UNITED STATES  
NUCLEAR REGULATORY COMMISSION  
WASHINGTON, D. C. 20555

LICENSEES: Babcock & Wilcox Owner's Group consisting of Arkansas Power and Light Company, Florida Power Corporation, Metropolitan Edison Company and Sacramento Municipal Utility District

MEETING WITH B&W OWNER'S GROUP CONCERNING PERMANENT SOLUTION TO SMALL BREAK PROBLEM, JUNE 9, 1978

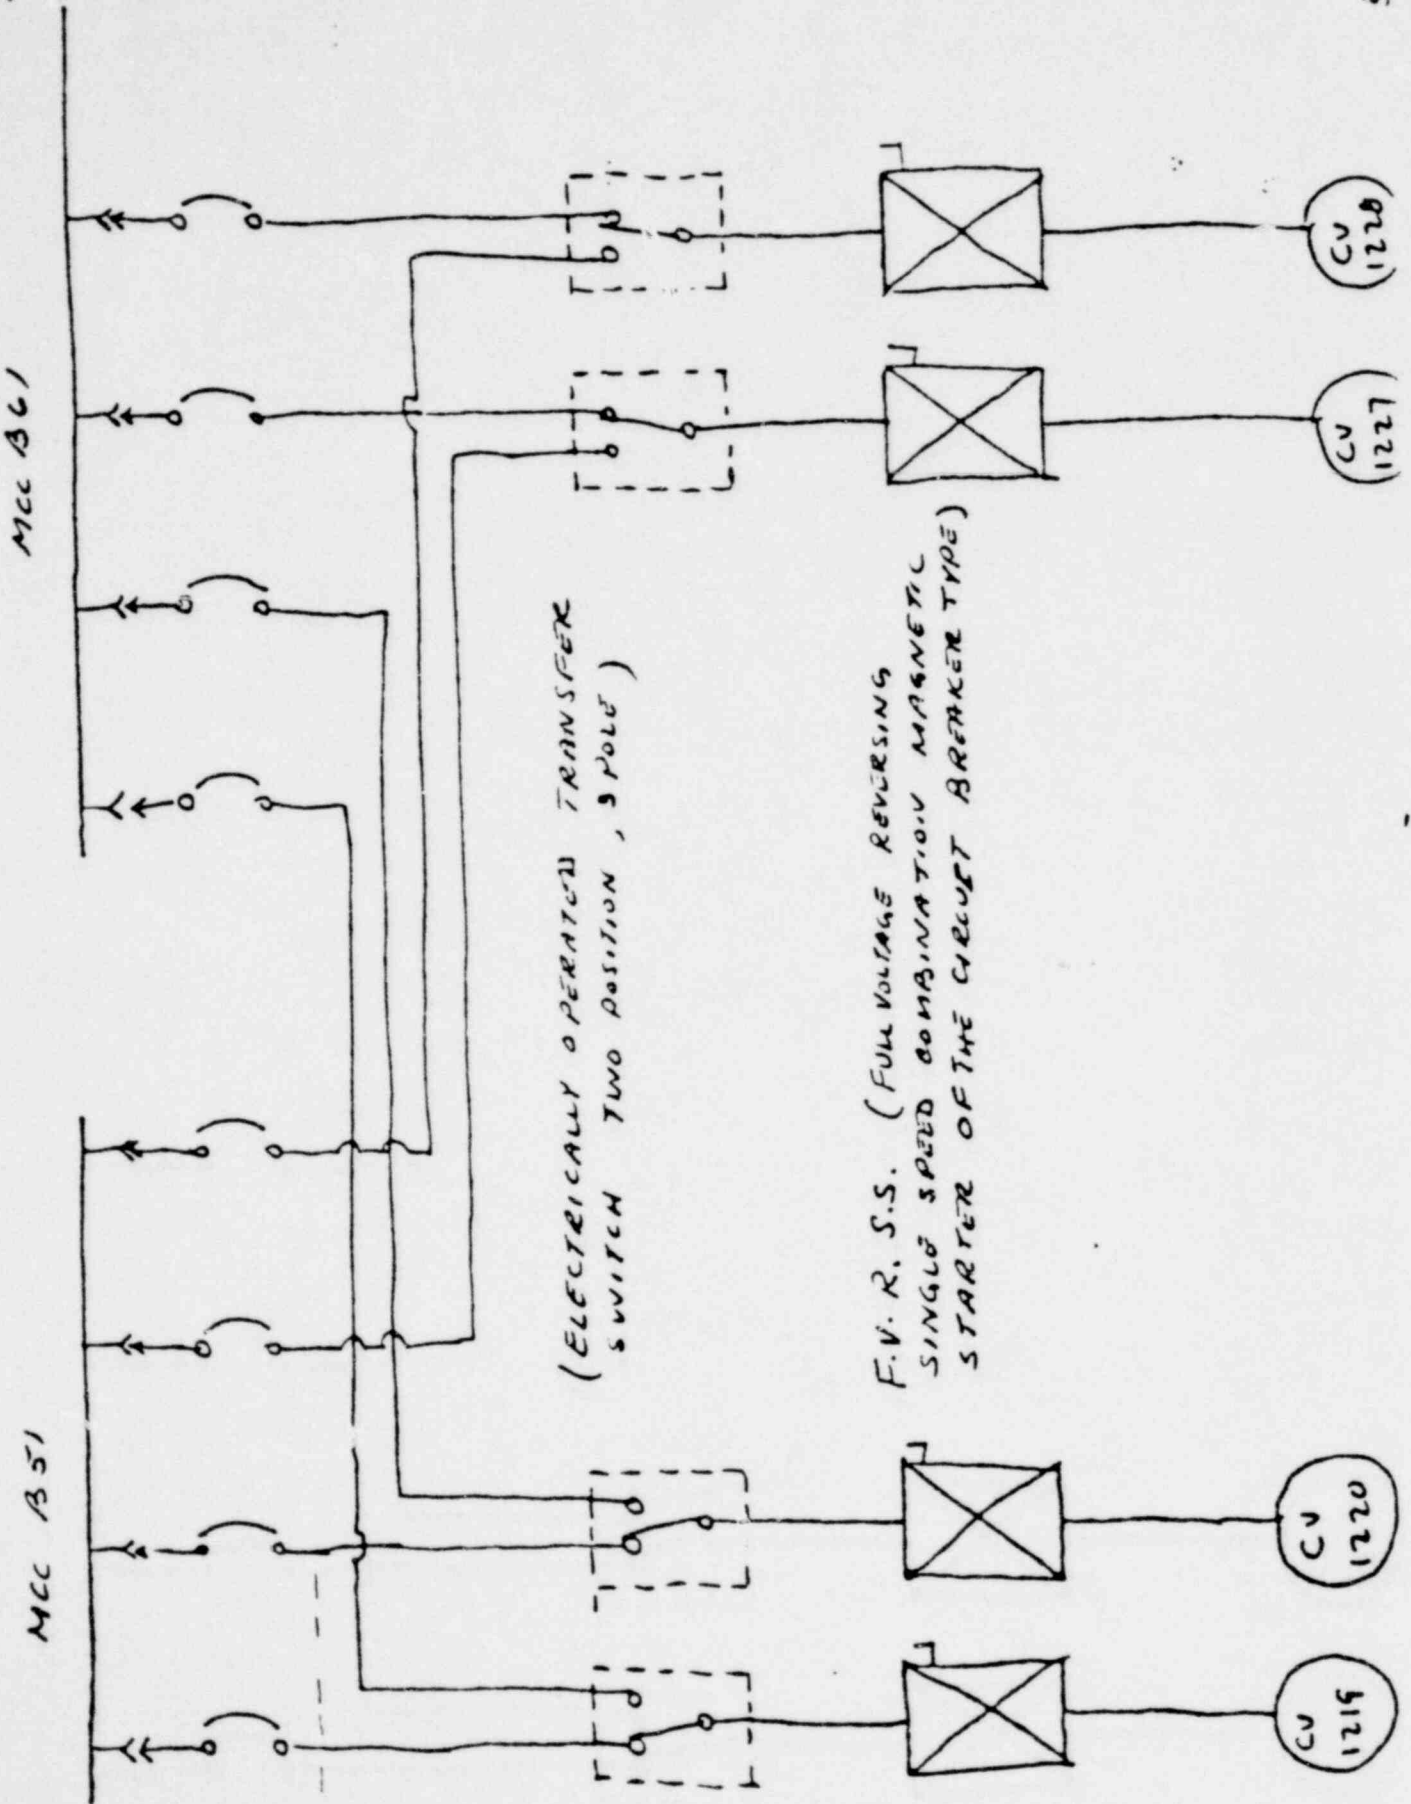
The proposed solution to the small break problem consisted of (1) opening the cross over valve, (2) powering the motor operated injection valves from either division through a manual actuated (from the control rooms) transfer switch (attachment 2).

The staff advised that the proposed solution was not acceptable as a permanent solution because (1) operator action was required within 10 minutes of the break and (2) of a single failure at the transfer switch. However, the proposed solution could be acceptable as an interim solution until the permanent solution was accepted if the single failure could be eliminated.
